PROJECT: AMER TOBACCO WATERLINE REPLACEMENT PH1
DATE: April 24, 2020

DEPARTMENT OF WATER MANAGEMENT
CITY OF DURHAM, NORTH CAROLINA

ADDENDUM NUMBER 2

PROJECT: **American Tobacco Waterline Replacement – Phase 1**

**TYPICAL CITY PAVEMENT REPLACEMENT
0251307R**

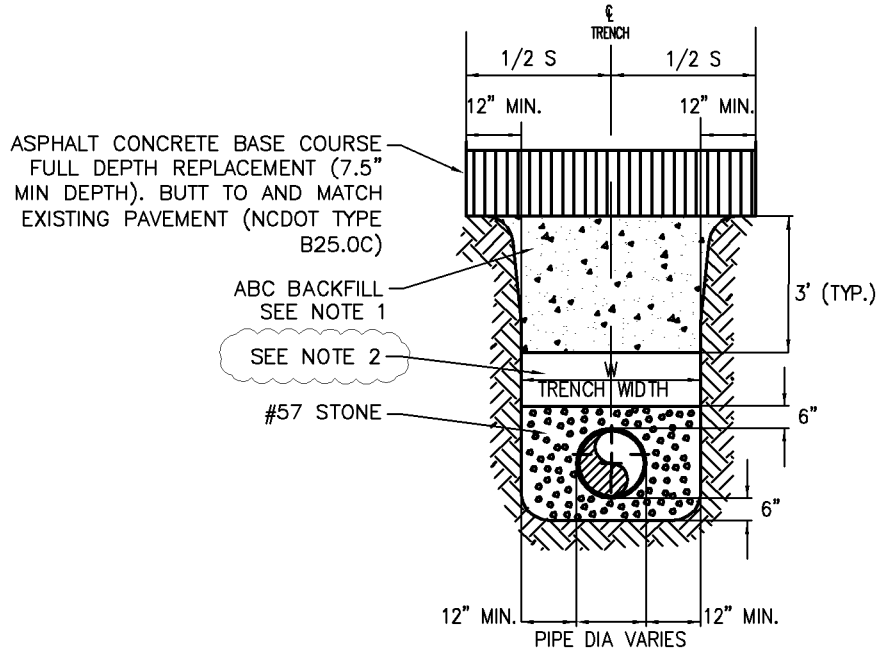
1. PLAN SHEET D-5

- Detail 0251307R; Remove and replace Detail 0251307R (Typical City Pavement Replacement) with Detail 0251307R on Attachment No. 1.

- NOTES:**
1. COMPACT ABC BACKFILL IN 8" LIFTS TO 95% STANDARD PROCTOR.
 2. IF ADDITIONAL FILL IS REQUIRED, CONTRACTOR MAY BACKFILL SELECT FILL IN 6" LIFTS COMPACTED TO 95% STANDARD PROCTOR, OR ABC BACKFILL AS DIRECTED.
 3. FOLLOWING FINAL COMPLETION, THE PAVEMENT REPLACEMENT AREA SHOWN ON THE PLANS (OR AS DIRECTED BY THE ENGINEER) SHALL BE MILLED TO 1.5" DEPTH AND RESURFACED WITH 1.5" ASPHALT CONCRETE SURFACE COURSE (NCDOT TYPE S9.5C). MILLING AND RESURFACING SHALL BE PHASED TO MINIMIZE THE NUMBER OF "JOINTS" IN SURFACE COURSE.
